New Albany Planning Commission Agenda
Monday, June 3, 2024 at 7:00 p.m.

FDP-22-2024 Final Development Plan

New Albany Planning Commission
Monday, May 6, 2024 Meeting Minutes - DRAFT

New Albany Planning Commission
DRAFT Meeting Minutes
Monday, May 20, 2024

August 2023 (Figure 1)

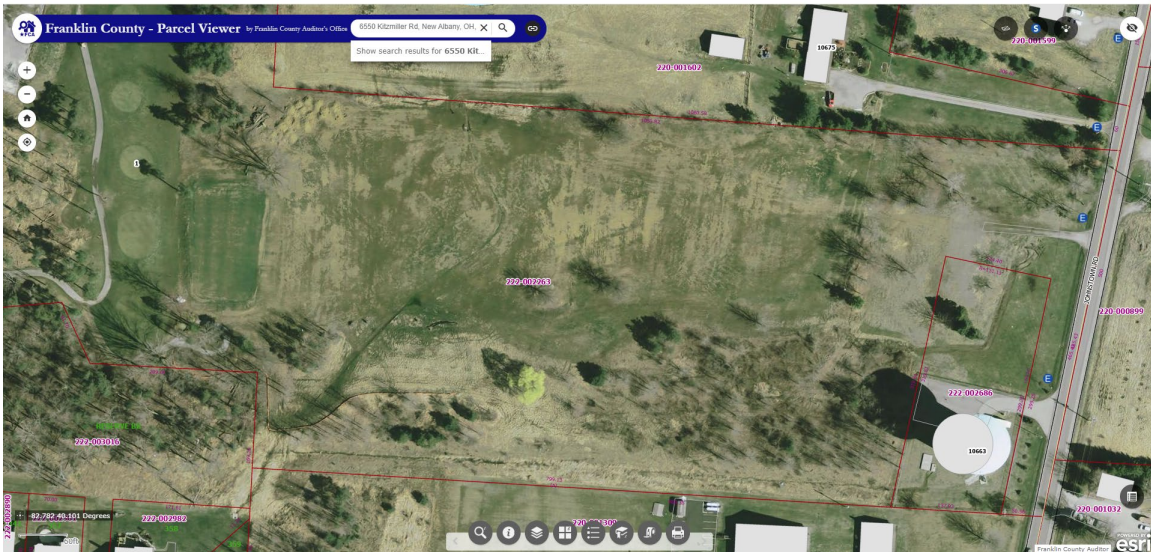
The owner has changed the site landscaping approved in 2009 by removing trees from the north and south property lines. Since the existing conditions do not match the approved 2009 final development plan, and the property requests changes to the landscaping, a final development plan modification is required.

The images below show the existing conditions when the final development plan was approved in 2009 (Figure 2) and current 2023/2024 conditions (Figure 1).

Diagram 4: Possible Trajectories

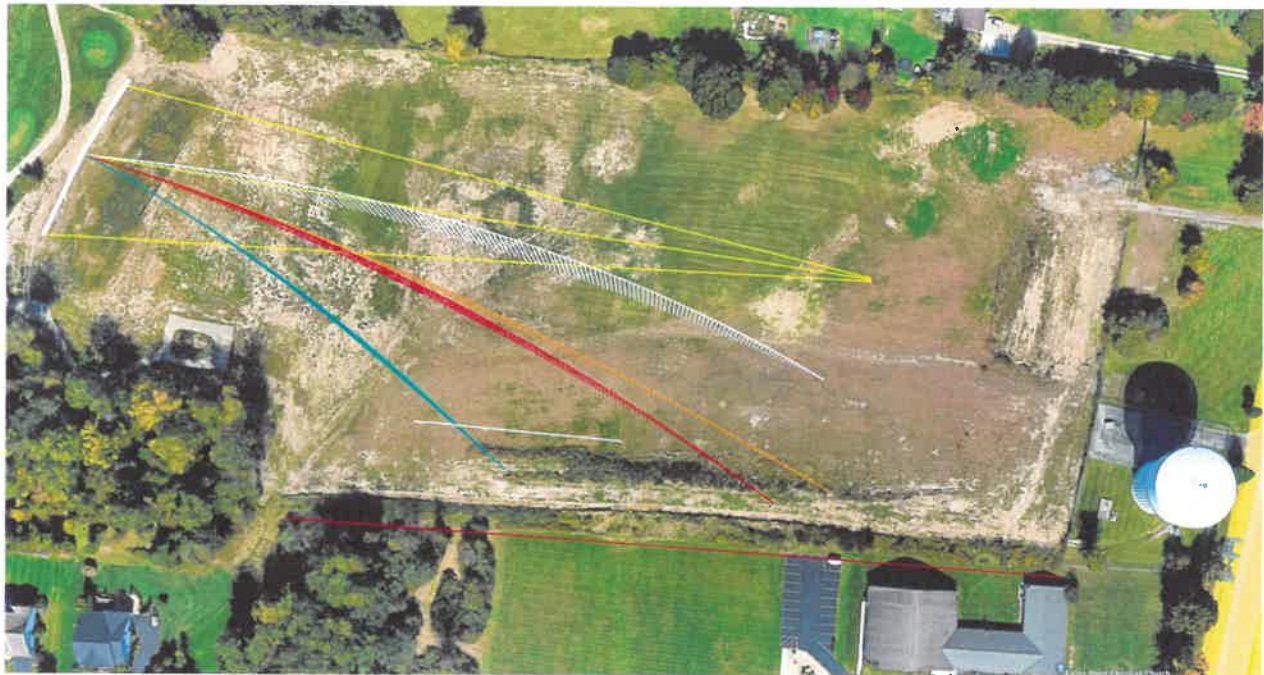
11. Diagram 4 below consists of 4 sample trajectories originating from the middle Tee Bay assuming standard range balls. My assumption is that all Tee Bays are aligned towards the same point thus all yellow target lines are aligned with the large middle tree at the end of the Range. All trajectories result from a 100 mph swing speed with a Driver of a right swinger. The WHITE trajectory is a slice with an initial direction along the yellow target line. The RED trajectory is the same slice but with an initial direction 10 degrees right of the yellow target line. The ORANGE trajectory is the same as the RED trajectory except with a 20 mph tailwind (note the lower trajectory due to the tailwind). The BLUE trajectory is a severe mishit off the toe of the Driver face that starts out 20 degrees right of the yellow target line (note that typical lower trajectory due to the mishit).

13. All trajectories would land short of the red property line. It's my understanding that the RED and ORANGE trajectories would land near a 6 foot high mound with planted trees. The blue trajectory would be blocked by the existing 50 foot high fence that has been installed.
14. Diagram 5 below contains the wind rose for Columbus, OH which is nearby. The prevailing wind is from the West and South, so either a tailwind, crosswind or tailwind/crossing. A tailwind reduces the height of the trajectories, and a crosswind would reduce the frequency of golf balls threatening the subject property.

Teeing Ground - Original Plan 2009

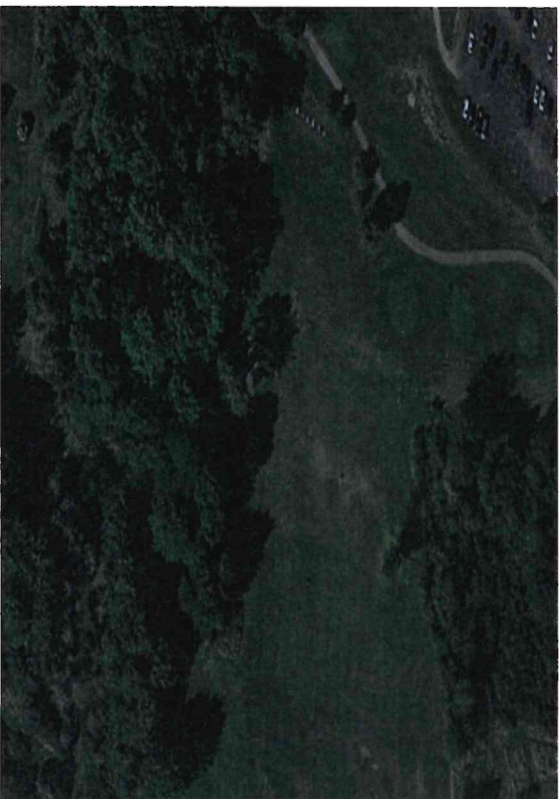
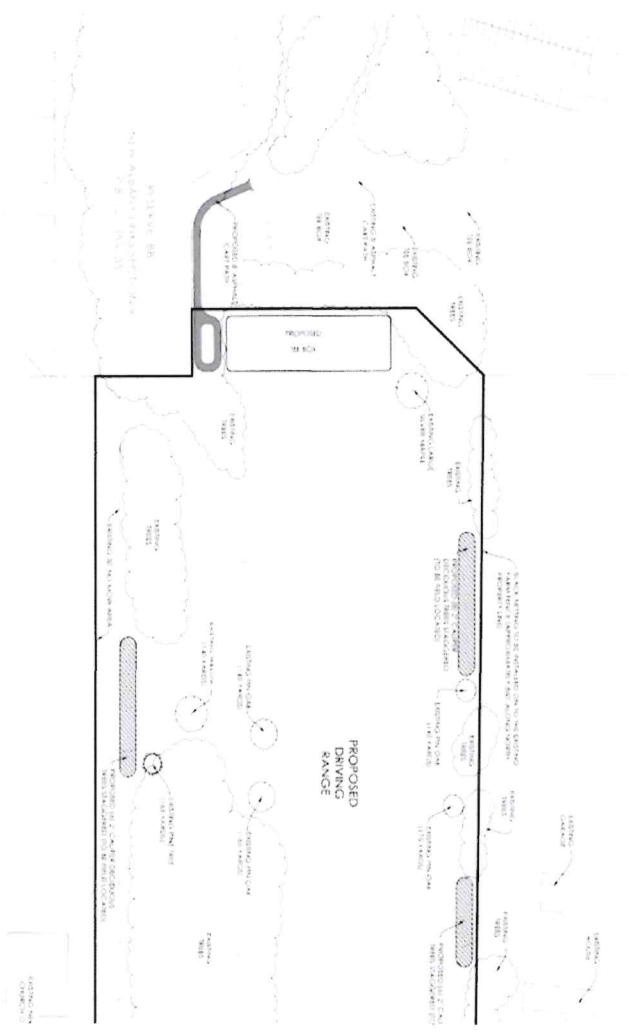
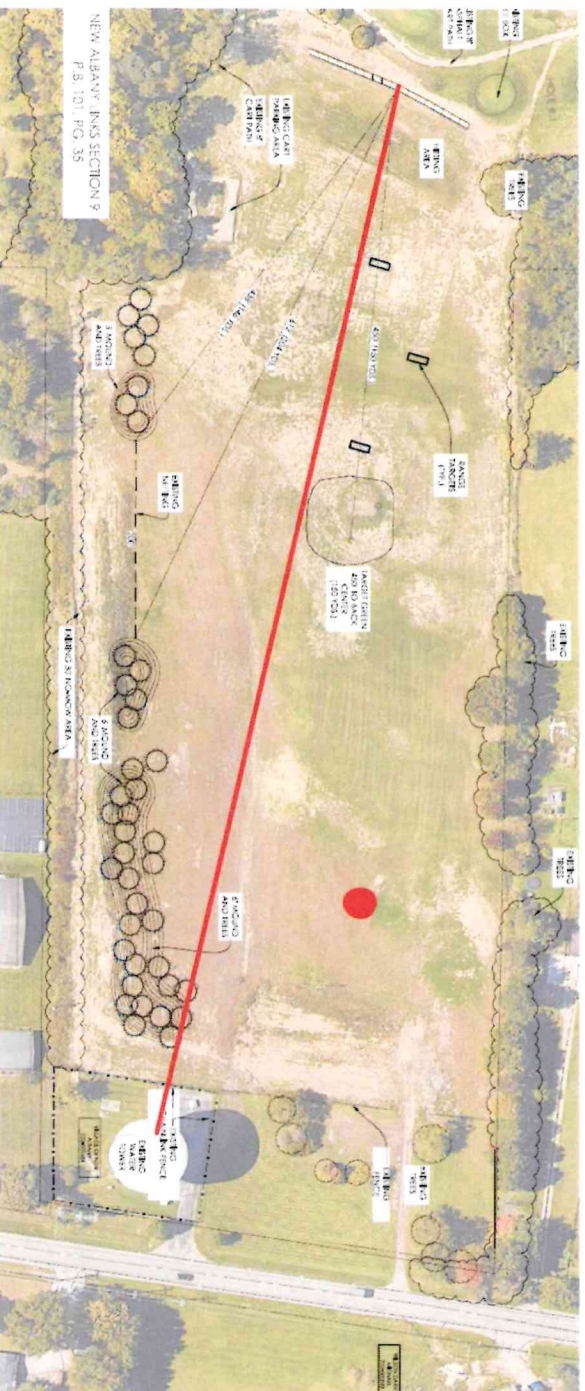
Mr. Ingram responded that the applicants had examined that, the teeing area of the prior owner was pushed much further back than where it exists today. He agreed that the teeing area was moved and the angle was added. He explained that their expert saw no utility in removing the angle.
